Letter No. 14151/FR.10/2022 - 2, dated 17.02.2023

Sub: Forests - Forest (Conservation) Act, 1980 – Vellore Circle / Tiruvannamalai forest Division – Proposal (No.FP/TN/IRRIG/118339/2021) for diversion of 0.90 Ha of forest land in Pennaiyar Reserved Forest in Tiruvannamalai Forest Division area for construction of fuse plug pertaining to Thandampattu Taluk of Tiruvannamalai District for discharge of heavy floods from Sathanur Reservoir in Tiruvannamalai District in favour of Assistant Executive Engineer, PWD Sathanur Dam, Tiruvannamalai District – Site inspection report – Reply / Comments – called for – Regarding.

Site Inspection Report of S Sasikumar IFS, Deputy Inspector General of  
Forests (Central), Integrated Regional Office, Chennai

Proposal No: FP/TN/IRRIG/118339/2021

**Annexure-I**

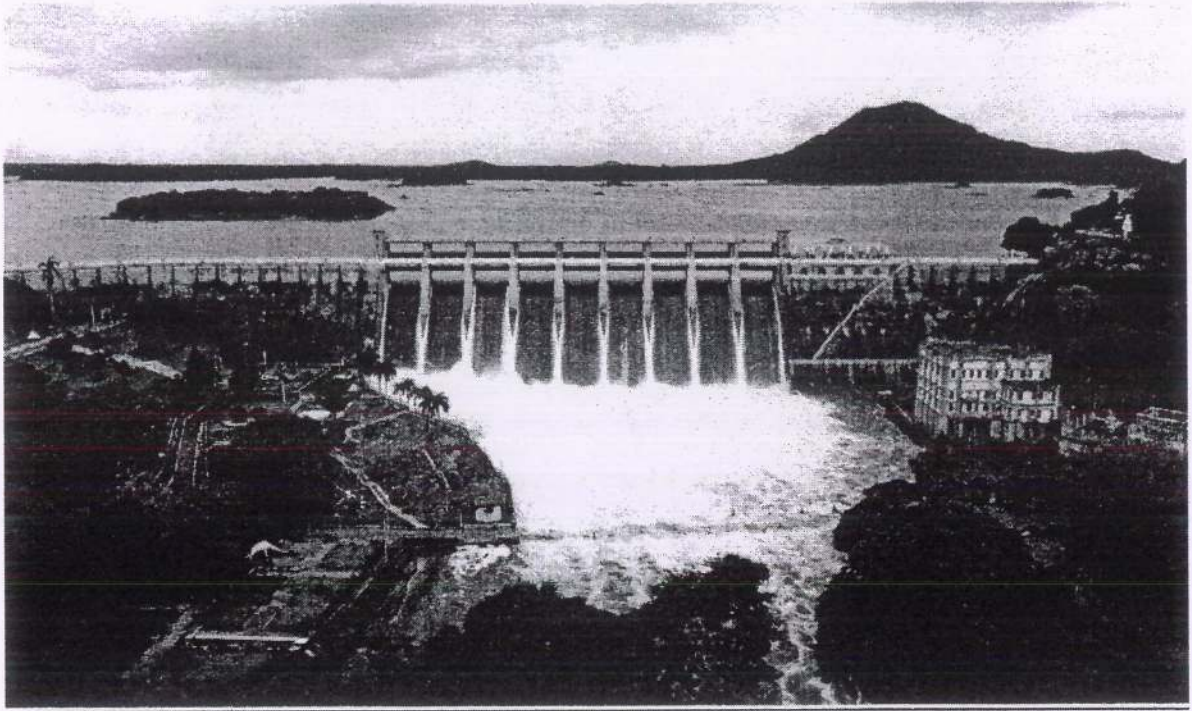
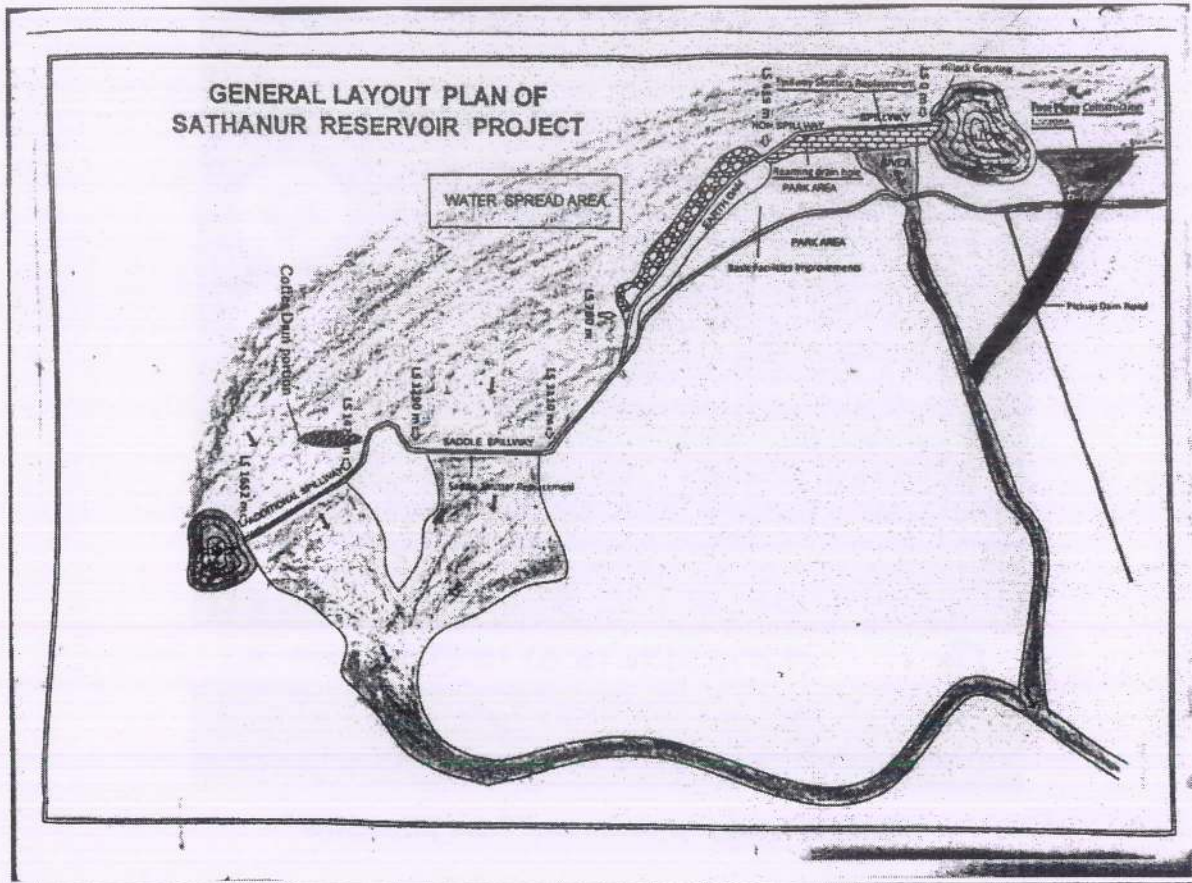
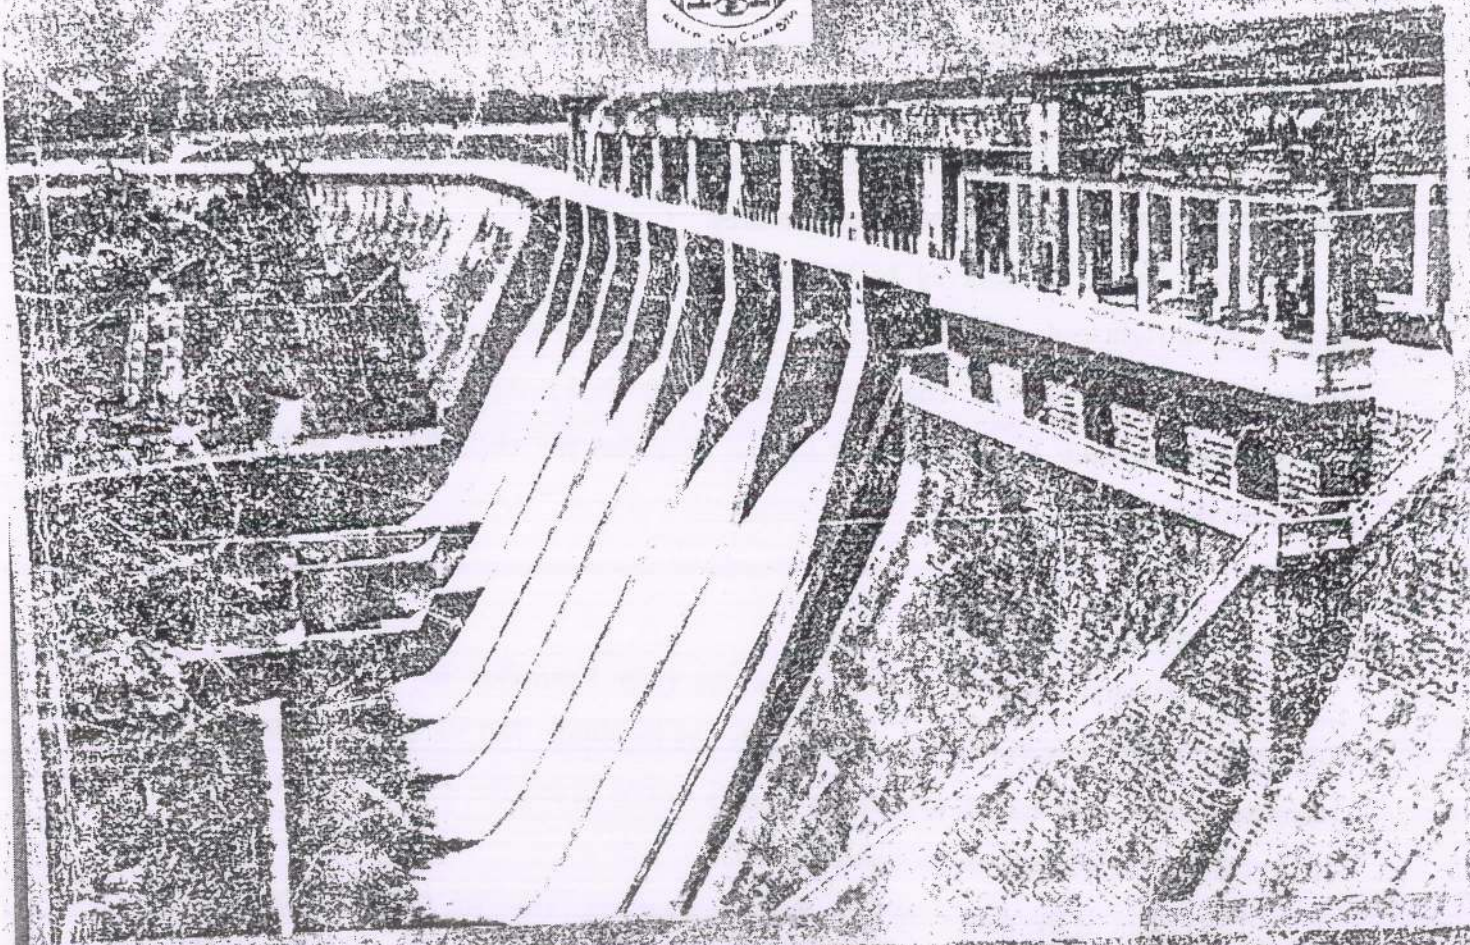
During the inspection, the authorities from Sathanur Sub Division has appraised the importance of having Fuse plug in case of having Probable Maximum Flood (PMF). It is informed that the present spillway, saddle and other outlets are not sufficient to dispose of the **PROBABLE MAXIMUM FLOOD (PMF)** value of 21181 m<sup>3</sup> /Sec. (748000 Cusecs). The undersigned has visited the proposed site for having Fuse plug, the existing spill ways, saddle and other outlets. Photos showing the filed visit is submitted here for information as **annexure-I**

Annexure-III

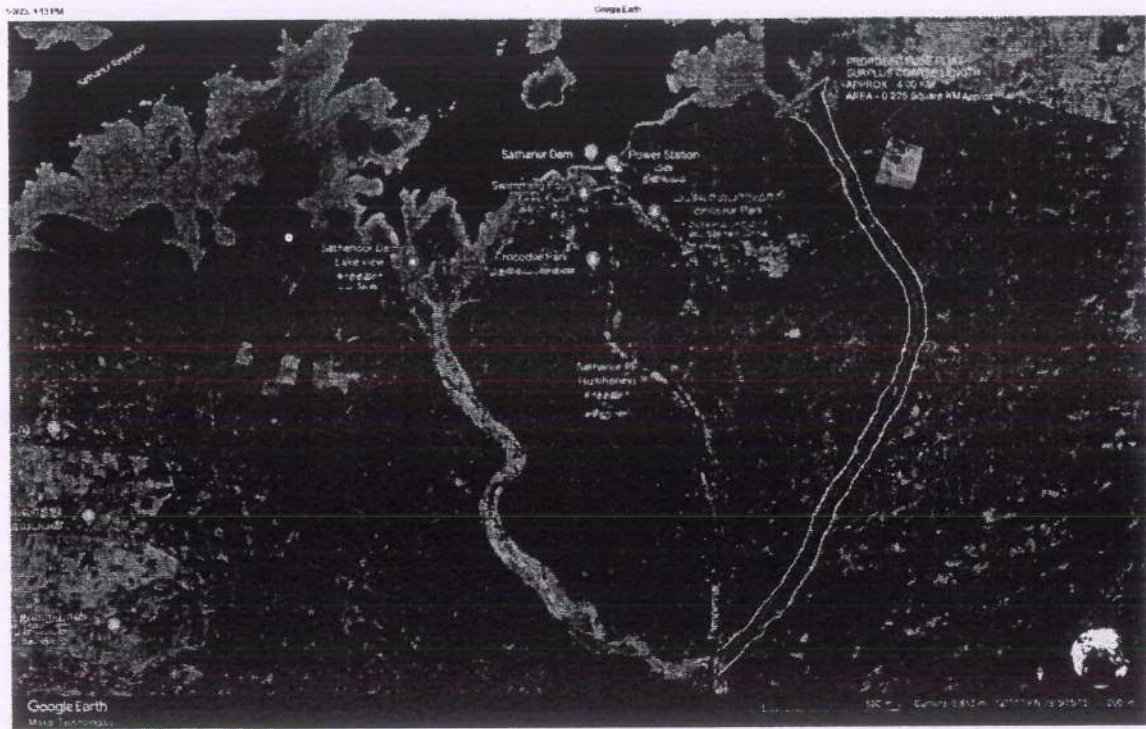
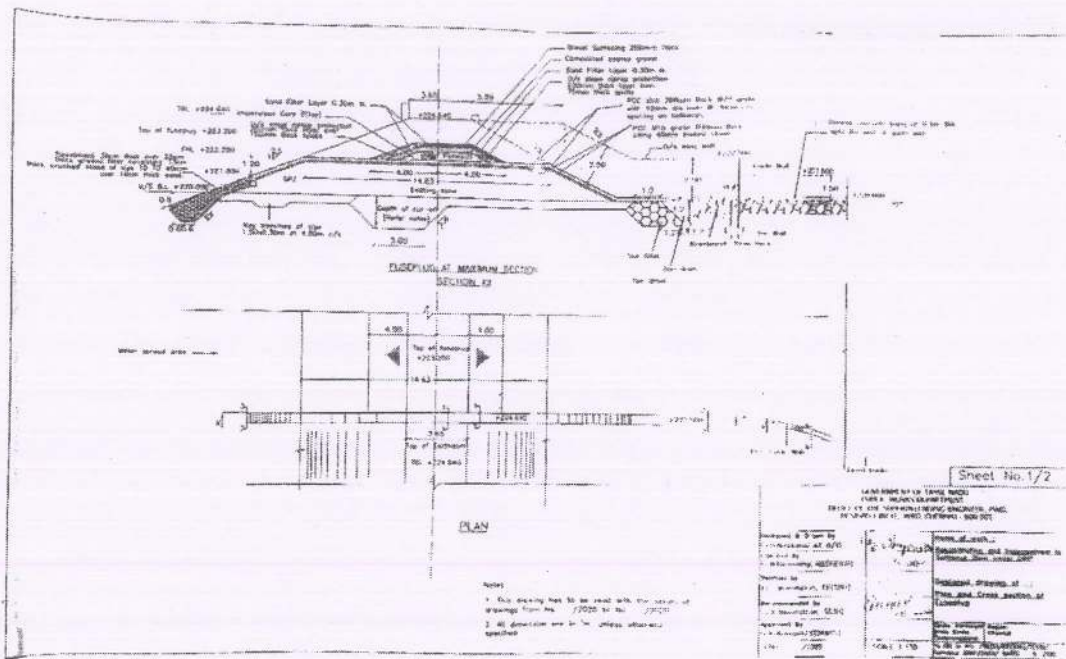
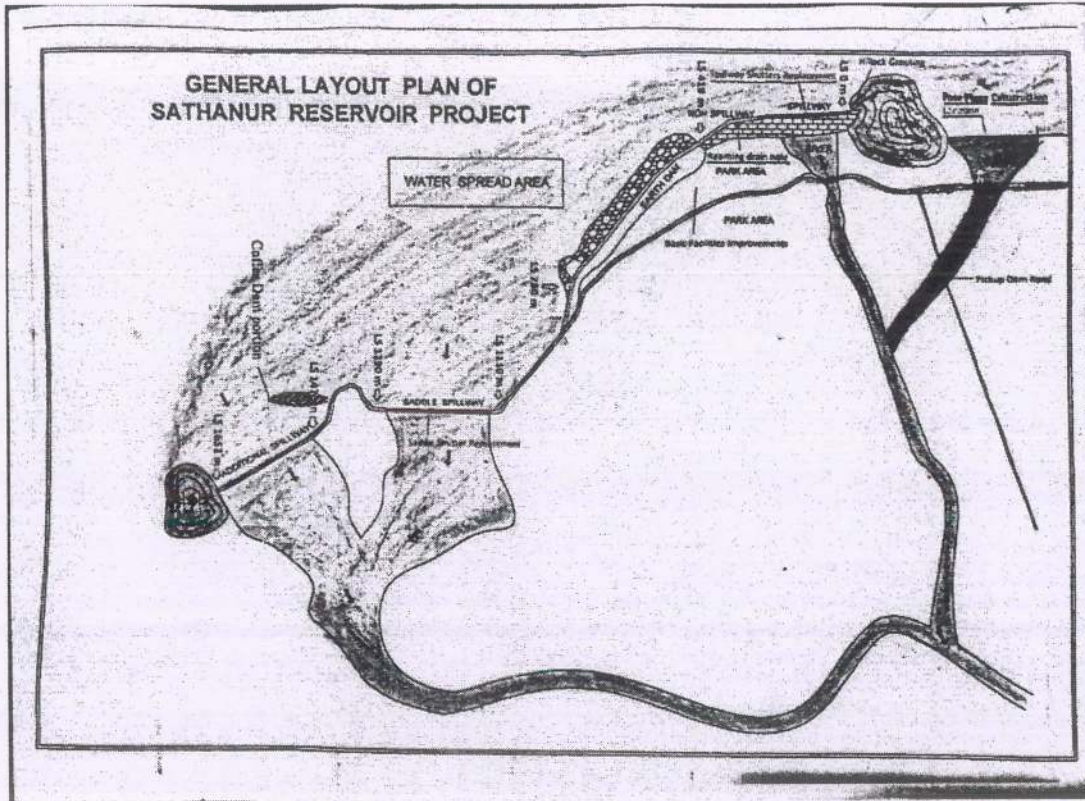
During the visit, it is seen that the dam is at full reservoir level (FRL). The water is seen to be leaking out of the dam through the natural gradient from the proposed site for construction of Fuse Plug. Photos showing the spill of water from the dam is submitted as **annexure-III**. And it is also seen that the water is being overflowing from the existing spillway, saddle and other outlets. At present there is no proposal from the User Agency to construct any channel to divert or connect this excess water to the main river. If it is allowed to go through the natural gradient and also through the existing walk way, it might cause huge damage to the trees present in the RF area. We may have to seek opinion from the State Government on this issue of excess water causing damage to the existing trees in the RF area. There is no contingency plan either proposed or submitted along with the proposal.

Water is at present over flowing from the propose fuse plug area. The dam is at full capacity

**Annexure-IV**

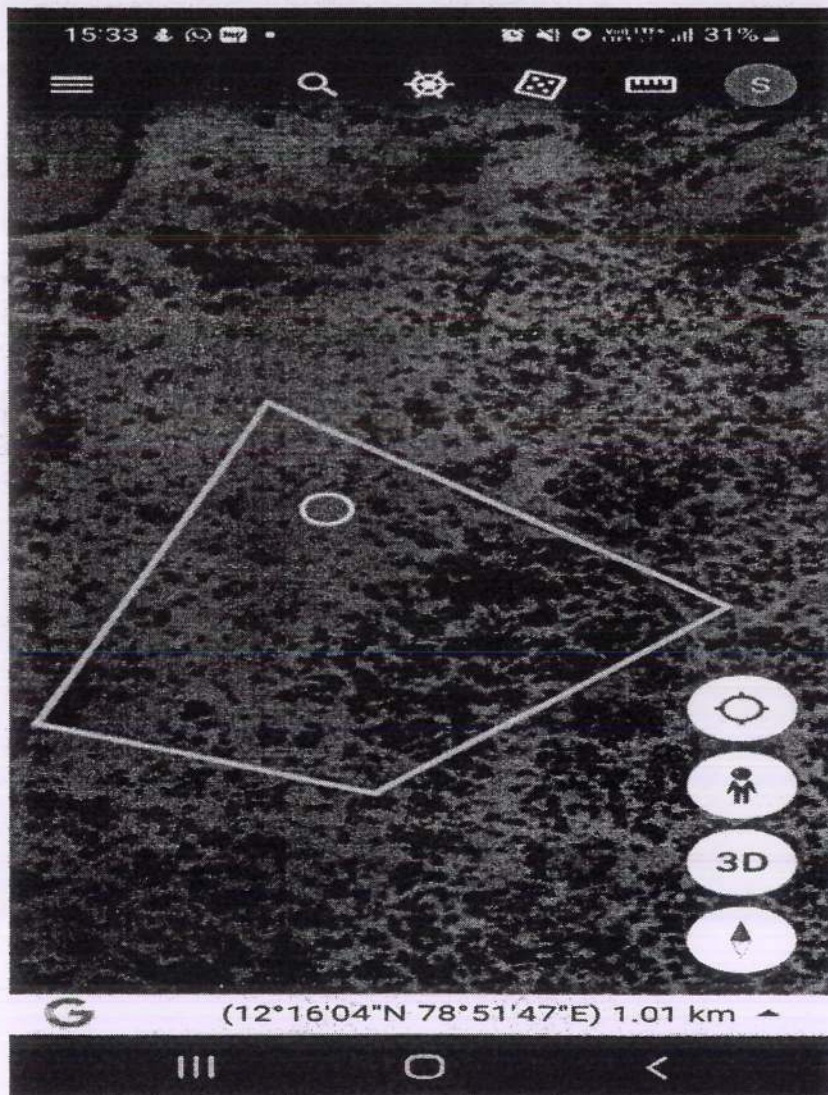
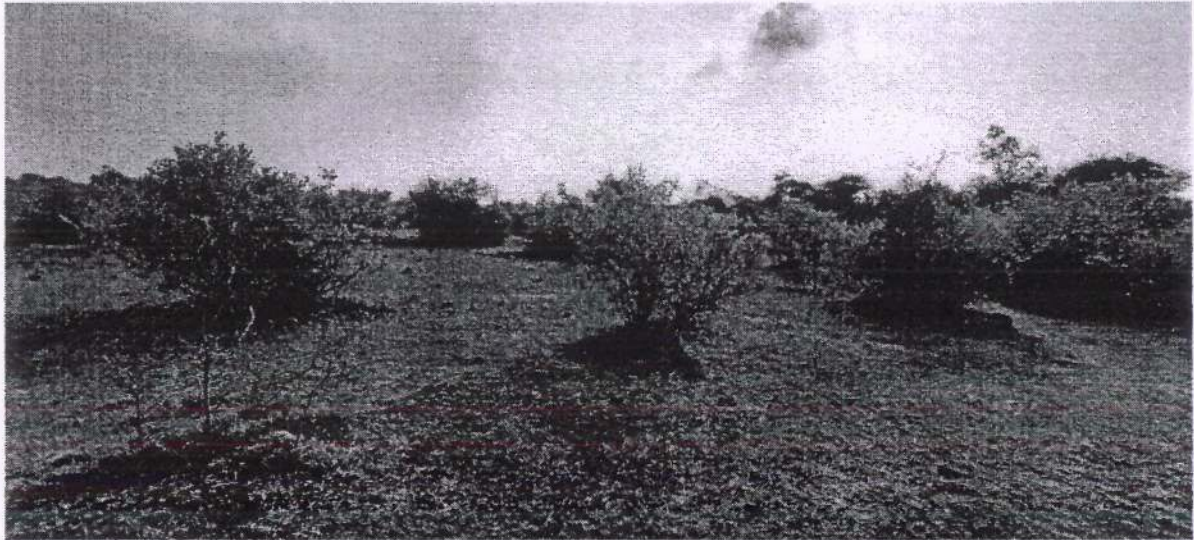
It is also seen that to connect such overflow water to the main stream, as such no canal can be constructed freshly, since, in the event of Probable Maximum Flood, where in around value of 21181 m<sup>3</sup> /Sec. (748000 Cusecs) of water would be expected to be discharged. It is very difficult to regulate such a huge volume of discharge. A tentative

pathway, worked out based on the gradient, through which the excess water is expected to be discharged is shown on Google map is submitted as **annexure-IV**. The area which is going to be affected due to this voluminous discharge needs to be worked out and the expected damage to the trees in RF need to be worked out.
